Technical product information

Topic	High pitched whistle from the engine - Warning light within the DIP - Engine not running smoothly - Numerous DTC's
Market area	Bentley; worldwide (2WBE)
Brand	Bentley
Transaction No.	2059379/2
Level	EH
Status	Approval
Release date

Bentayga - V8 Kovomo

Figure 2

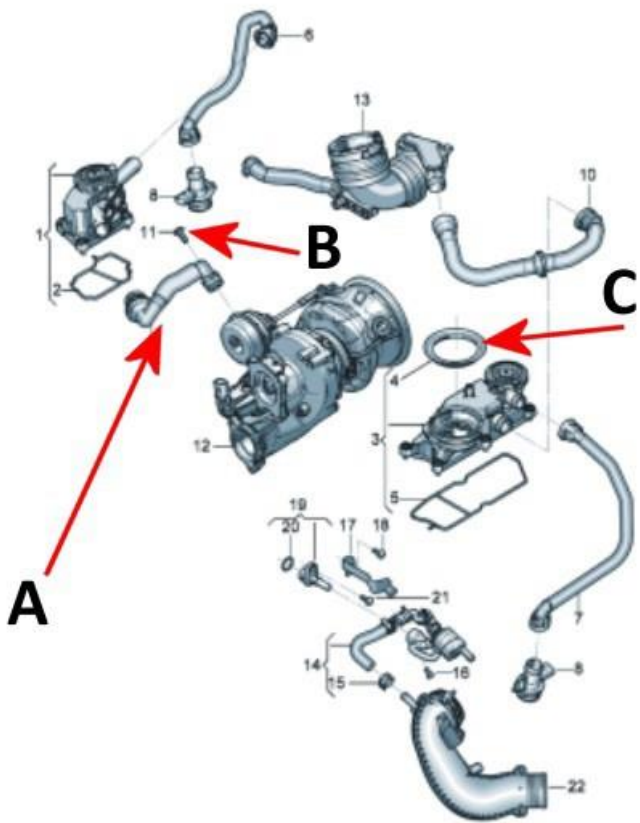
Air intake leak due to a broken one-way diaphragm valve from within the Bank 1 breather line

2) Referring to Figure 2 - Replace the Bank 1 breather line (Point A) and fixing (Point B) – Refer to applicable sections from Rep.Gr 10 - Oil mist separator bank 1 - To remove and fit

- Replace the oil filler pipe seal to the Bank 2 oil separator (Point C)

Figure 3

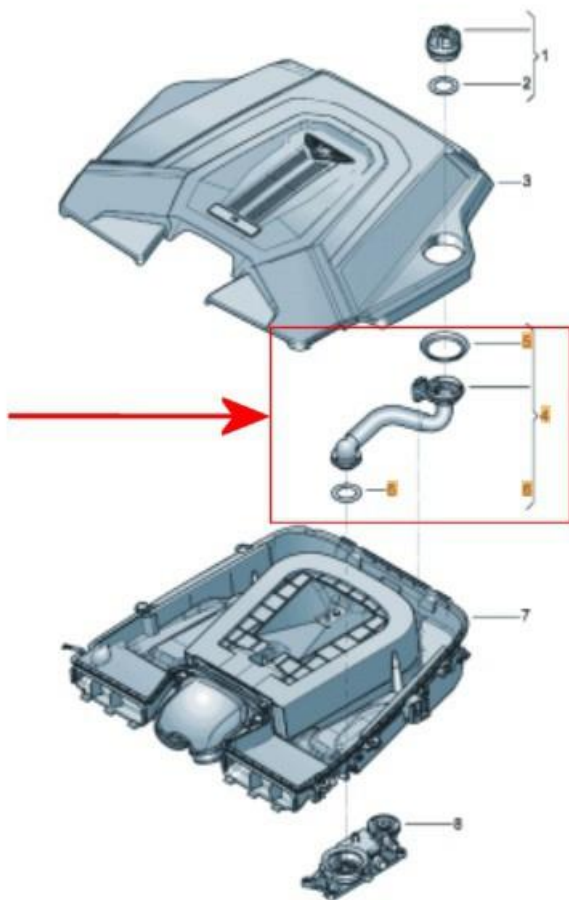
Replace the oil filler pipe including all seals (Figure 3) – Refer to applicable sections from Rep.Gr 10 - Oil mist separator bank 2 - To remove and fit
